Scientific Analysis/Calculation Error Resolution Document

1. Originator: Roger Henning	2. Date: 09/11/2008	3. ERD No. ANL-EBS-MD-000076 ERD 02
---------------------------------	------------------------	--

4. Document Identifier: ANL-EBS-MD-000076 REV 00 and ACN 01	5. Document Title: Analysis of Mechanisms for Early Waste Package/Drip Shield Failure
--	--

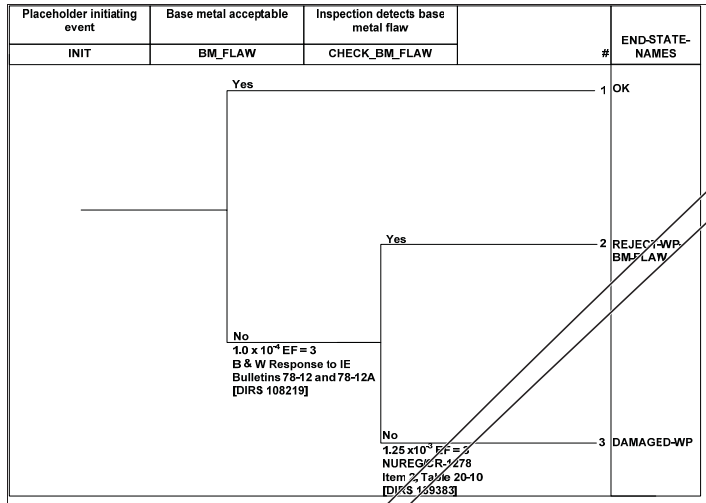
Author: rhennin	Subject: Replacement Text	Date: 9/10/2008 3:33:28 PM
03-16		
Author: rhennin	Subject: Replacement Text	Date: 9/10/2008 3:33:28 PM
03-16
